Access Compliance Report

Public Rights-of-Way

Intersection ID: 14792	Main Street: RANDOLPH_RD	Cross Street: VAN_NESS_ST	Location: NE
ADA ID: 01AAC32CF050	Ramp Type: Perp	Initial Pass/Fail: Fail	Overall Compliance: No
Severity Score: 1.25			
Codes/Mitigation Info/Possible Solution		Field Measurements/Component Compliance

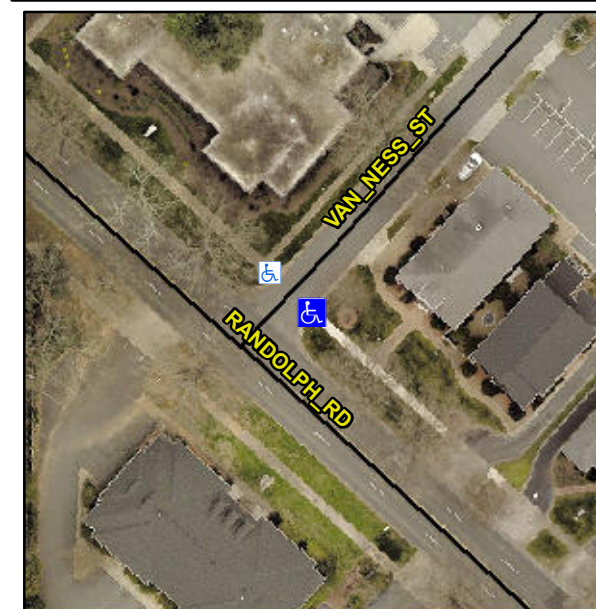
Not Found, R304.5.3

Compliance	Description	Data	Compliance	Description	Data
N/A	Ramp Length (in)	84.0	Yes	Ramp Slope (%)	6.6
Yes	Ramp Width (in)	48.0	No	Ramp XSlope (%)	2.8
N/A	Flare Type LT	N/A	N/A	Flare Type RT	N/A
N/A	Flare Slope LT (%)	N/A	N/A	Flare Slope RT (%)	N/A
N/A	Flare Traversable LT?	N/A	N/A	Flare Traversable RT?	N/A
N/A	Landing Length (in)	N/A	N/A	DWS Provided?	N/A
N/A	Landing Width (in)	N/A	N/A	DWS Contrast?	N/A
N/A	Landing Slope (%)	N/A	N/A	DWS Length (in)	N/A
N/A	Landing X Slope (%)	N/A	N/A	DWS Full Width?	N/A
N/A	Landing Curb? (Y/N)	N/A	N/A	DWS Offset (in)	N/A
N/A	Shared Landing?	N/A			
N/A	Gutter Ponding?	N/A	N/A	Gutter Slope (%)	N/A
N/A	Gutter Lip Ht (in)	N/A	N/A	Gutter X Slope (%)	N/A
N/A	Painted X Walk1?	No	N/A	Painted X Walk2?	N/A
	X Walk 1 Direction	To NW		X Walk 2 Direction	N/A
N/A	X Walk 1 Width (in)	N/A	N/A	X Walk 2 Width (in)	N/A
	X Walk 1 Slope (%)	6.6		X Walk 2 Slope (%)	N/A
	X Walk 1 X Slope (%)	2.5		X Walk 2 X Slope (%)	N/A

Remove & Replace Entire Ramp.
